ORDINANCE NO. 2020-01-___

AN ORDINANCE AMENDING CHAPTER 122, "CONSTRUCTION REGULATIONS," ARTICLE II, "BUILDING CODES," BY AMENDING SECTION 122-25 *INTERNATIONAL BUILDING CODE AND INTERNATIONAL RESIDENTIAL CODE ADOPTED*, SECTION 122-26 *AMENDMENTS TO BUILDING AND RESIDENTIAL CODES*, SECTION 122-30 *INTERNATIONAL MECHANICAL CODE ADOPTED AMENDMENTS*, SECTION 122-31 *INTERNATIONAL PLUMBING CODE ADOPTED*, SECTION 122-32 *AMENDMENTS TO INTERNATIONAL PLUMBING CODE*, SECTION 122-34 *INTERNATIONAL FUEL GAS CODE ADOPTED*, SECTION 122-35 *INTERNATIONAL ENERGY CONSERVATION CODE ADOPTED*, SECTION 122-36 *AMENDMENTS TO ENERGY CONSERVATION CODE*, AND SECTION 122-38 *INTERNATIONAL PROPERTY MAINTENANCE CODE ADOPTED*, AND ADDING SECTION 122-40 *INTERNATIONAL SWIMMING POOL AND SPA CODE ADOPTED*; AND AMENDING CHAPTER 126, "HOUSING," ARTICLE II, "SUBSTANDARD STRUCTURES," BY AMENDING SECTION 126-40 *INTERNATIONAL PROPERTY MAINTENANCE CODE ADOPTED*, FOR THE PURPOSE OF ADOPTING THE 2018 EDITIONS OF SUCH INTERNATIONAL CODES AND BY THE ADOPTION OF LOCAL AMENDMENTS TO SUCH INTERNATIONAL CODES INCLUDING BUT NOT LIMITED TO CERTAIN RECOMMENDATIONS BY THE NORTH CENTRAL TEXAS COUNCIL OF GOVERNMENTS, AND PROVIDIN

****Figure R602.6.1; delete the figure and insert the following figure:**

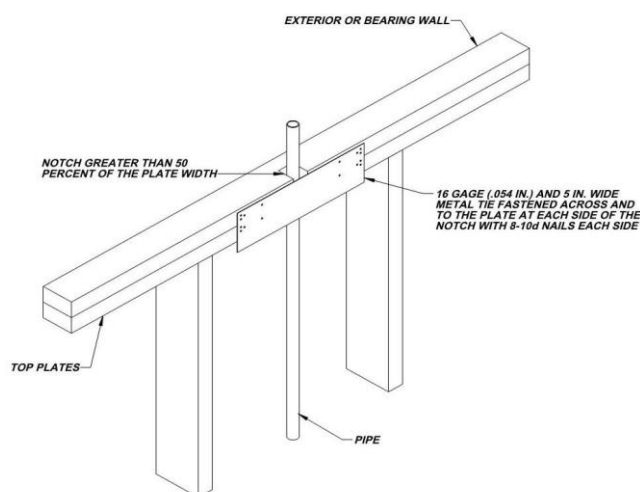
R602.6.1 Drilling and notching of top plate. When piping or ductwork is placed in or partly in an exterior wall or interior load-bearing wall, necessitating cutting, drilling or notching of the top plate by more than 50 percent of its width, a galvanized metal tie not less than 0.054 inch thick (1.37 mm) (16 Ga) and 1½ inches (38 mm) 5 inches (127 mm) wide shall be fastened across and to the plate at each side of the opening with not less than eight 10d (0.148 inch diameter) having a minimum length of 1 ½ inches (38 mm) at each side or equivalent. Fasteners will be offset to prevent splitting of the top plate material. The metal tie must extend a minimum of 6 inches past the opening. See figure R602.6.1. *{remainder unchanged}*

(Amendment to 2015 IRC carried forward to 2018 IRC also provides additional assurance of maintaining the integrity of the framing by spreading the nailing pattern.)

ADD: Figure: 25 TAC §265.186 (e) (6)

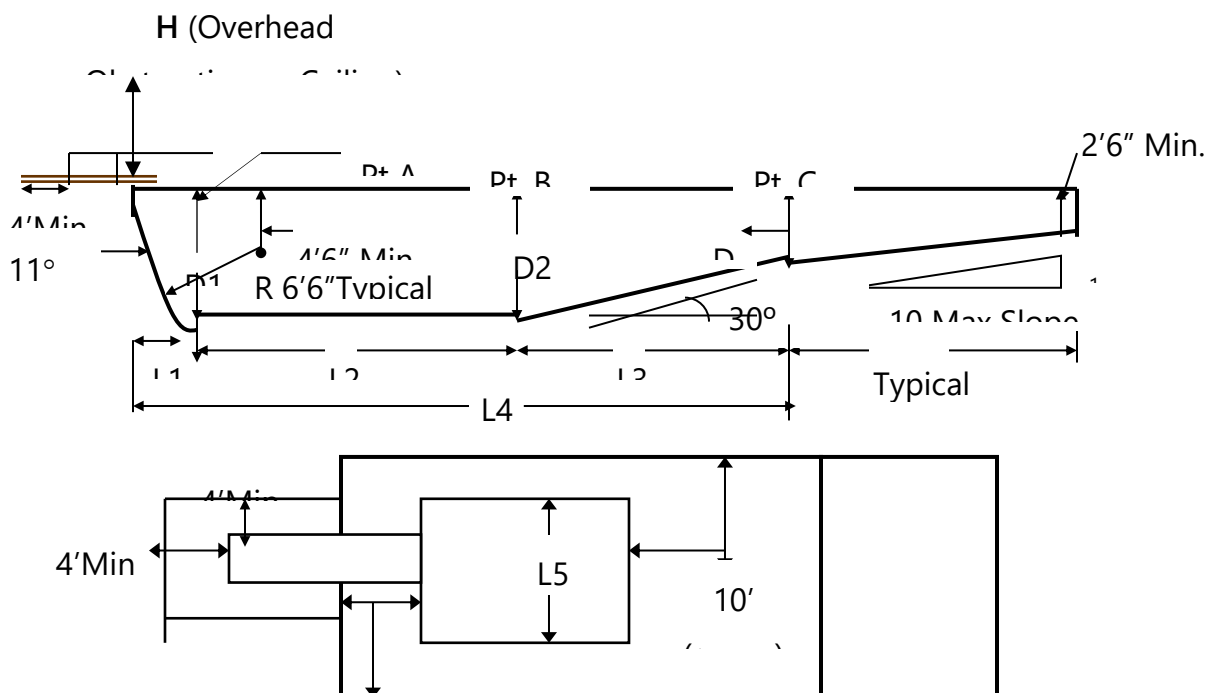
402.12 Water envelopes. The minimum diving water envelopes shall be in accordance with Table 402.12—Texas department of State Health services, Administrative Code Title 25, Chapter 265, Section 186 (e) and Figure: 25 TAC 256.186 (e) (6). (Delete Table 402.12 and Figure 402.12)

(Reason: To avoid conflict with 25 TAC Chapter 265.)
